RECEIPT DATE: 2/22/23 **ONSITE SEWAGE DISPOSAL SYSTEM**

I have the following revision comments that need to be addressed on the OSDS plan submittal from November 9th, 2021.

ONSITE SEWAGE DISPOSAL SYSTEM DESIGN PLAN

HAY MEADOW OVERLOOK
LOT 2
PLAT No. 21740
530 WATERSVILLE ROAD, MOUNT AIRY, MD, 21771
TAX MAP 2, GRID 15, PARCEL 18
4TH ELECTION DISTRICT
HOWARD COUNTY, MARYLAND
SCALE: 1" = 20'
JOB NO.: 3696
DATE: JUNE 2, 2022
SHEET: 1 OF 1

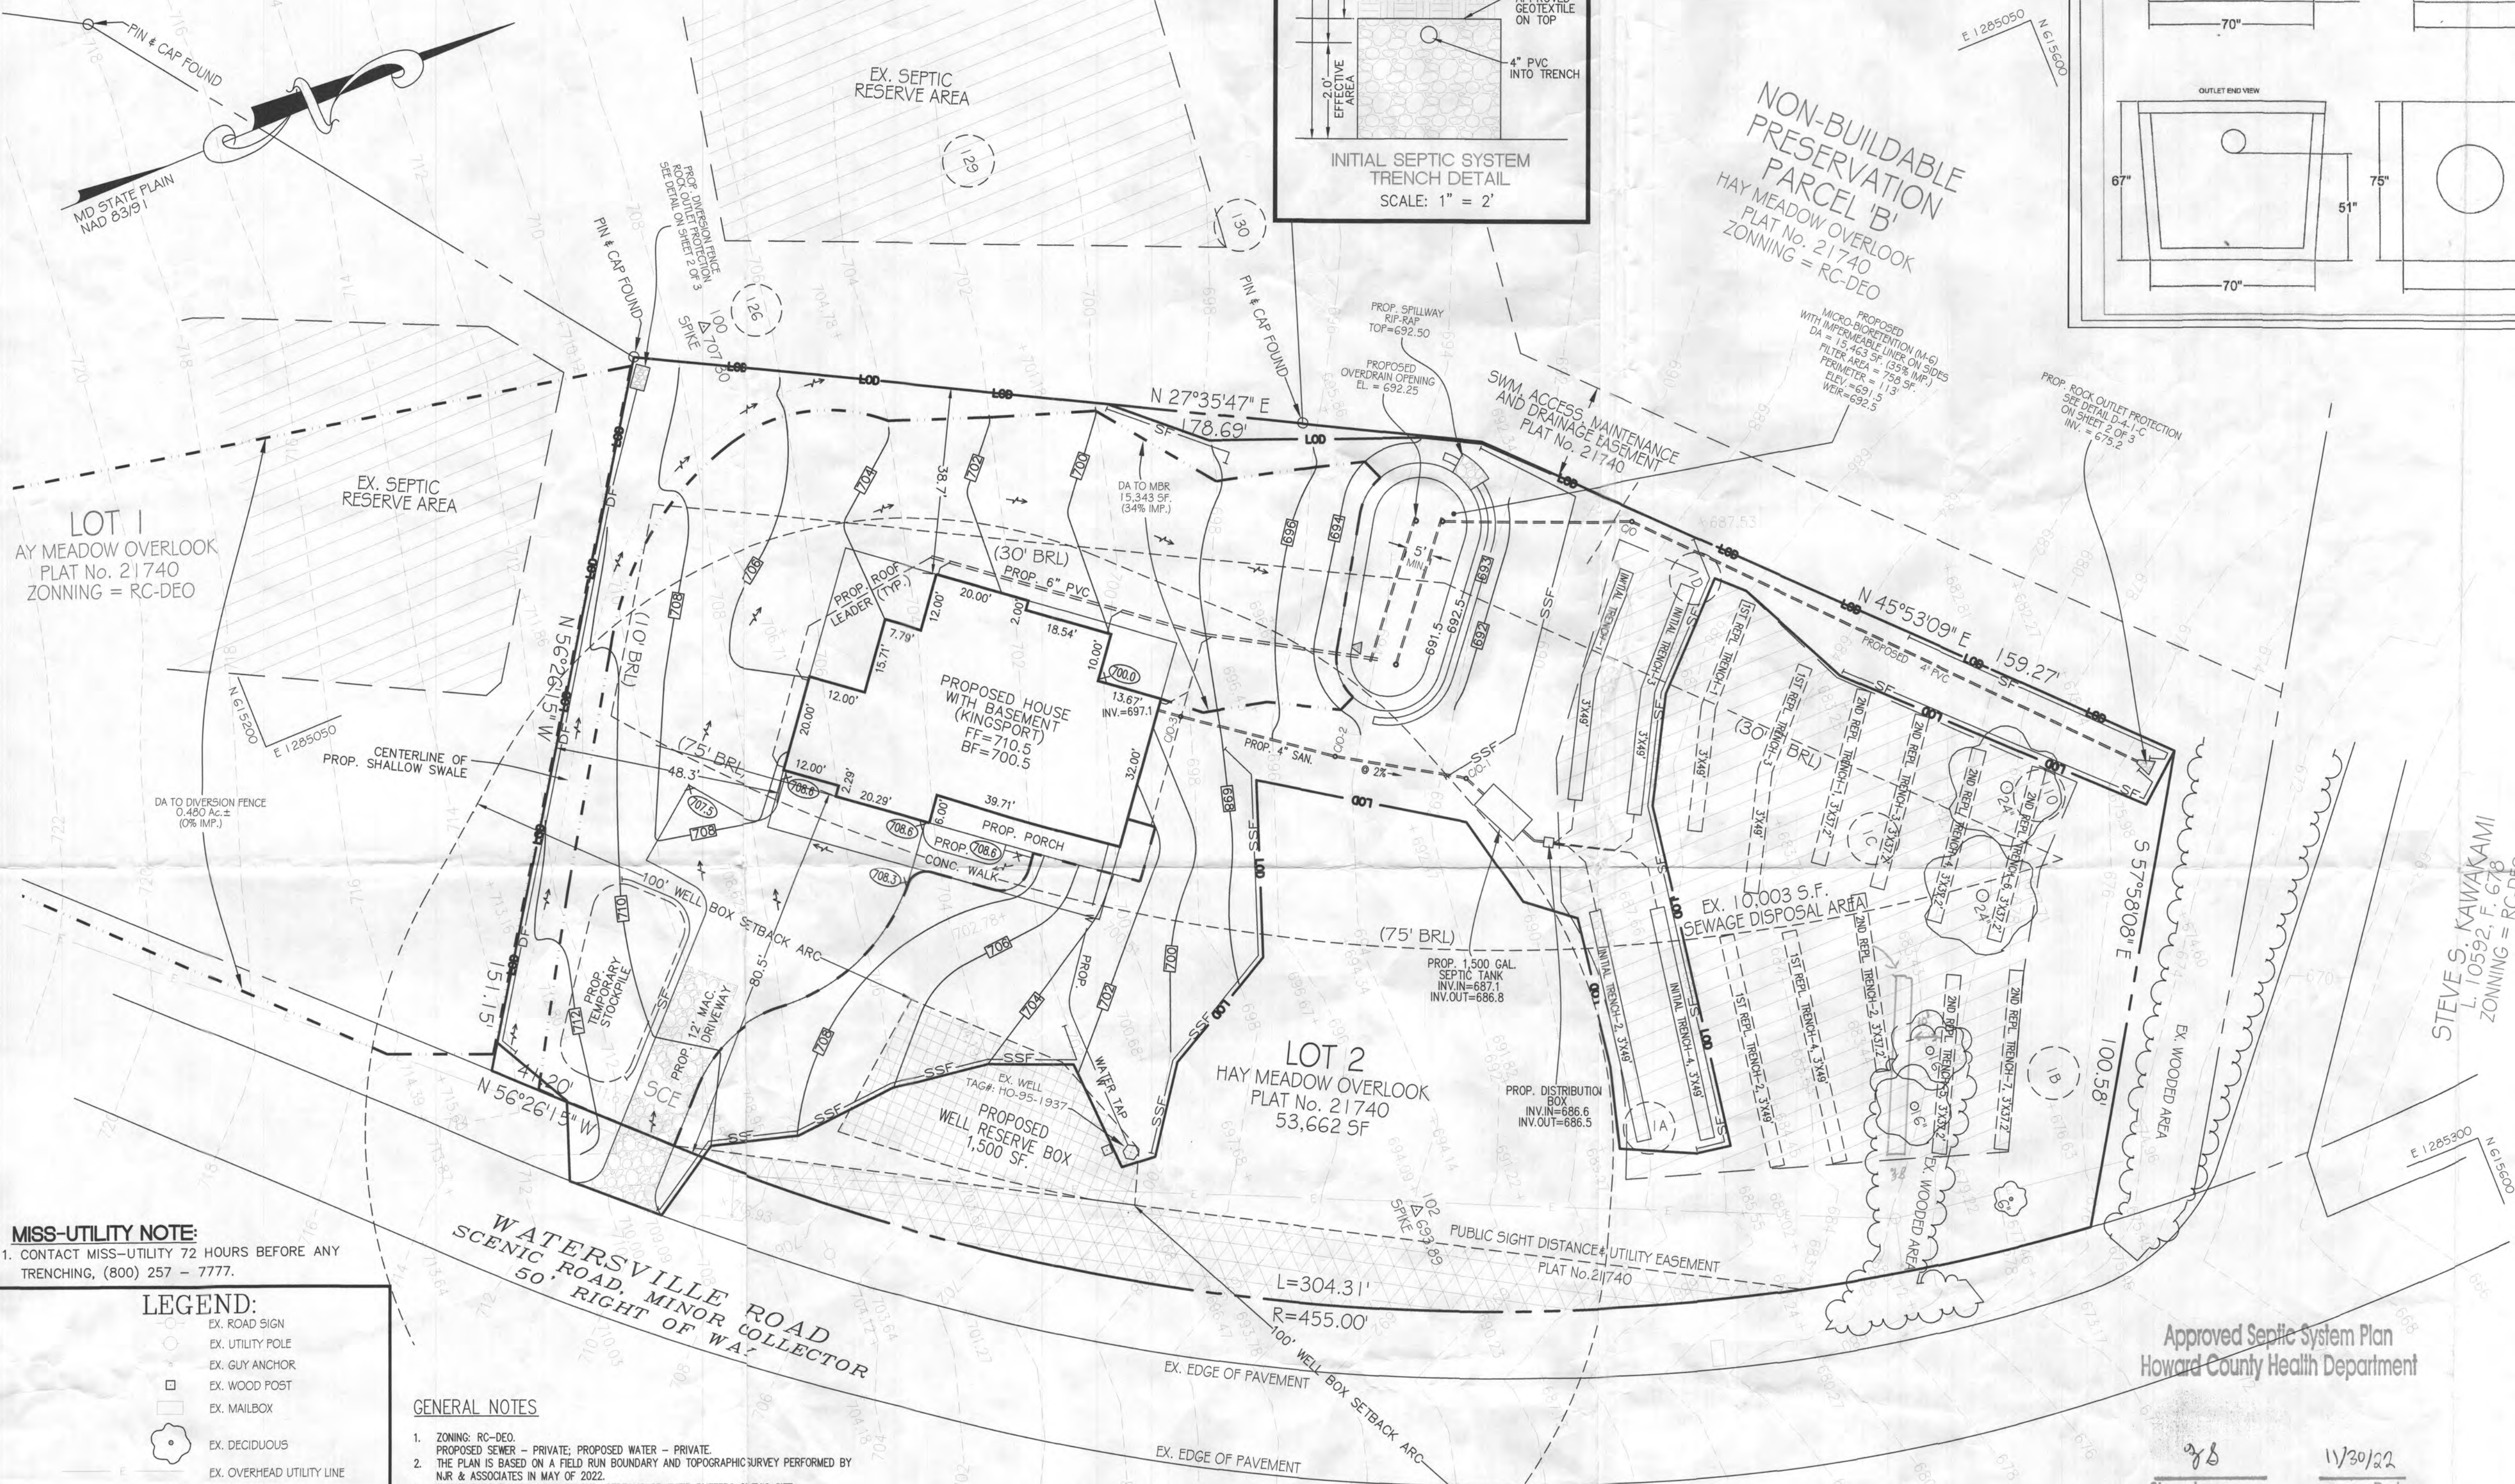
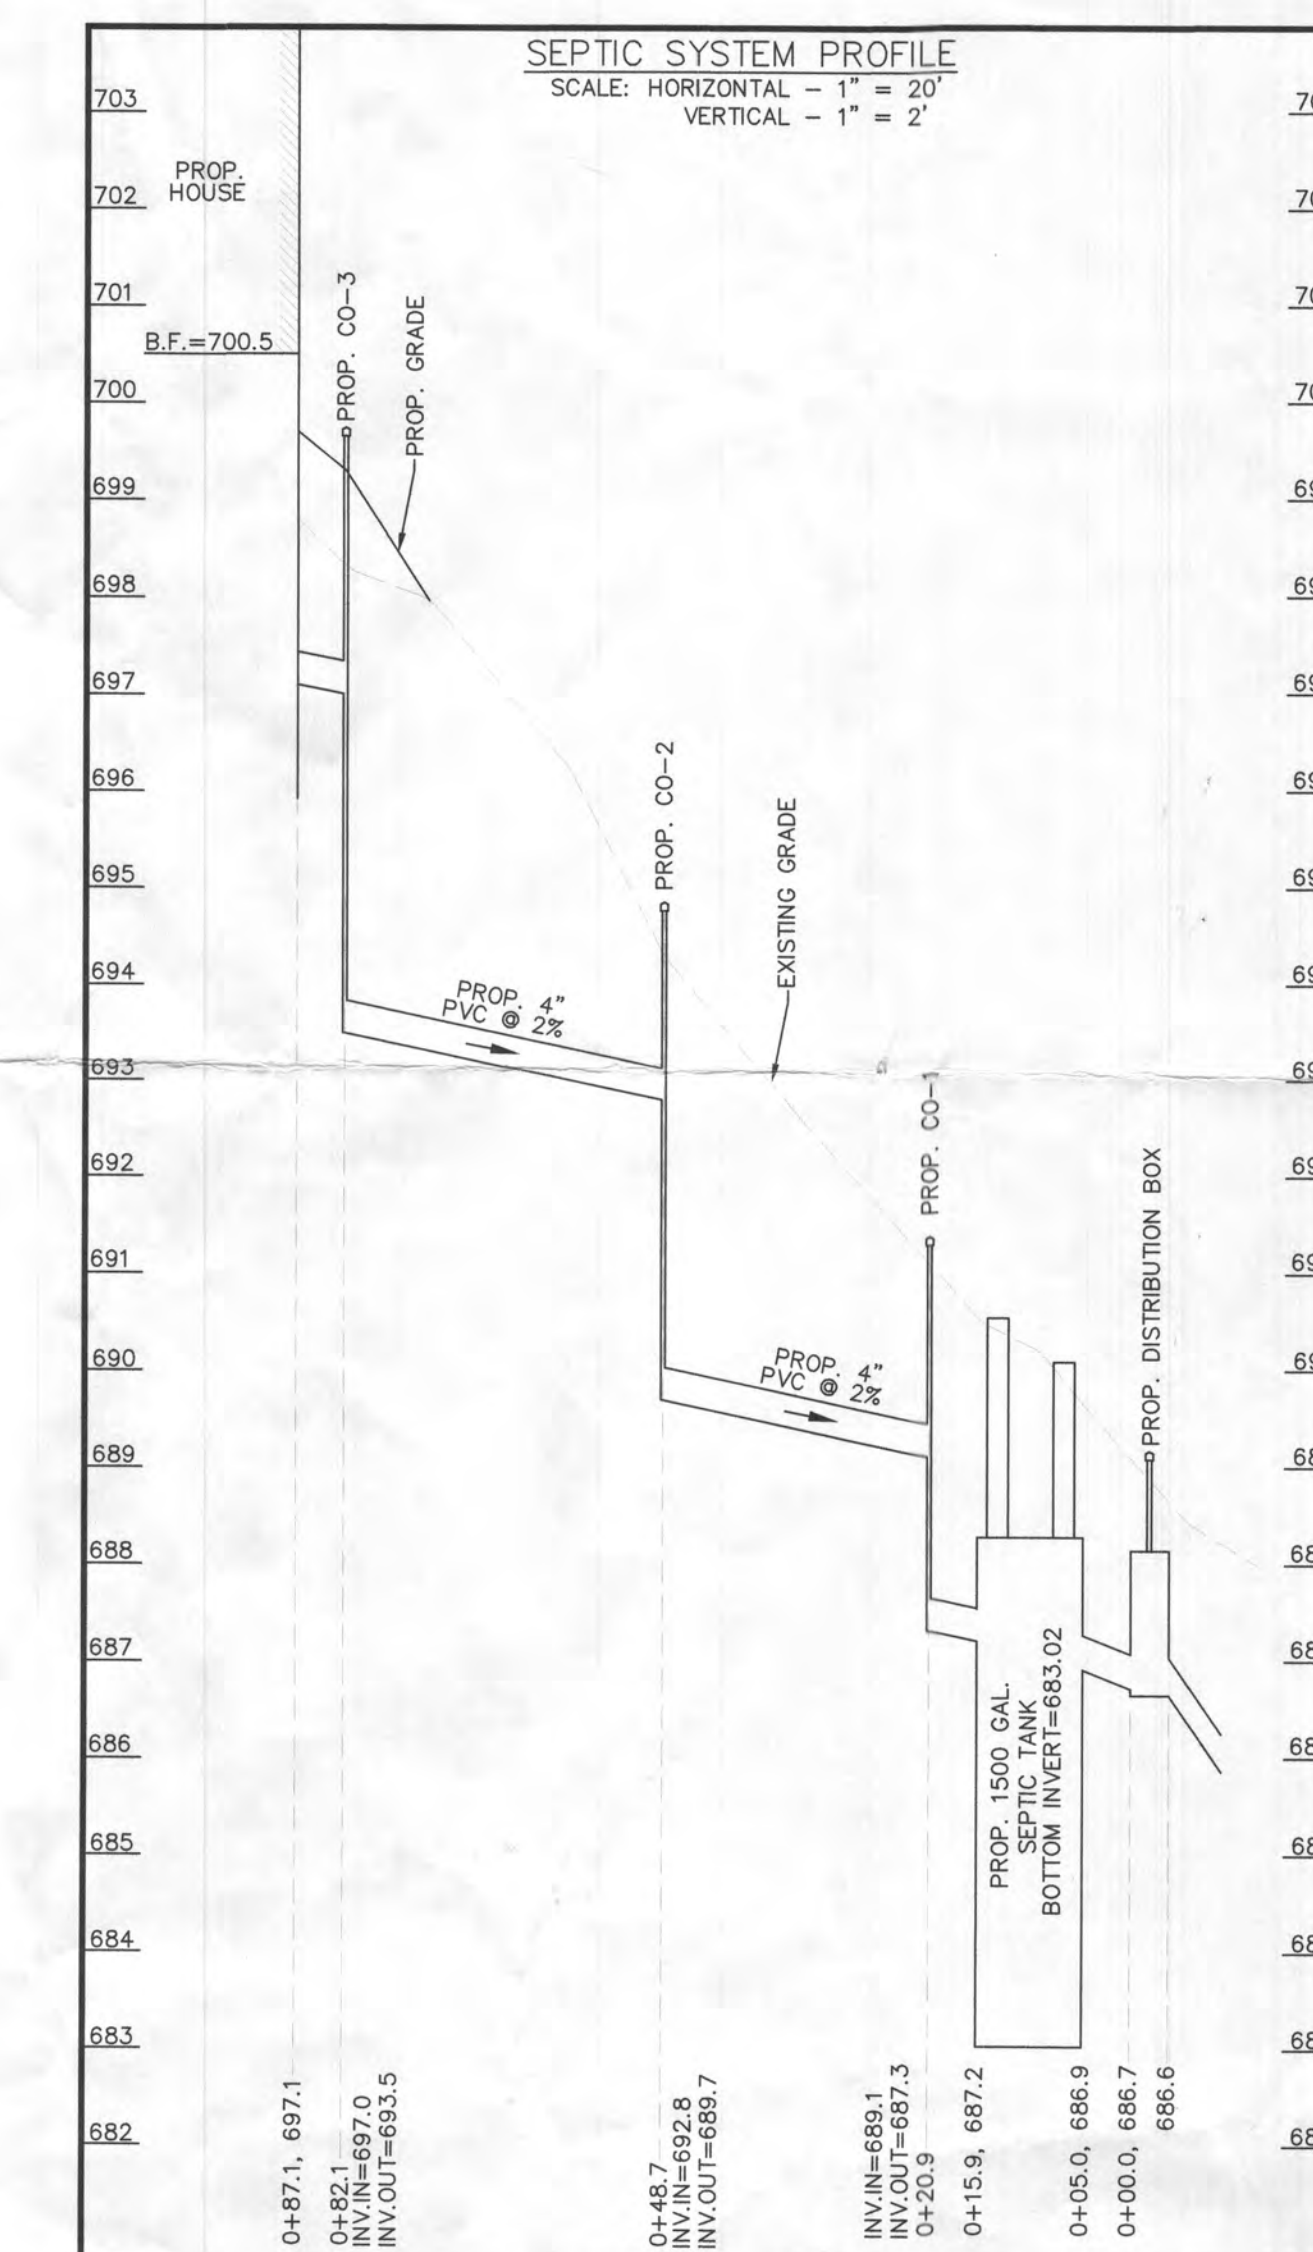
1. The newest stormwater management is in the direct path of the SDA and is not meeting the minimum 25' setback. This is not a rule that can be bent as expressed previously.
 - a. I don't see any issue with sliding it up 5-10' to meet the required setback.
 - b. Right now I'm measuring 20' off the edges.
2. The calculations involving the second replacement trench are 260 LF of trench. ON the plot plan it is showing the correct trench length of 37.5' for the seven trenches but in the written calculation it is calling for seven trenches @ 43.5'.
 - a. Please correct.
3. Trench labeled as "2nd replacement- trench 2" is not meeting the minimum setback between trenches at 10' and should be moved and positioned in a way that is more uniform with the other 6 trenches.
4. 10,000 sf SDA should be labeled as sewage disposal area on plot plan.
 - a. Please correct.
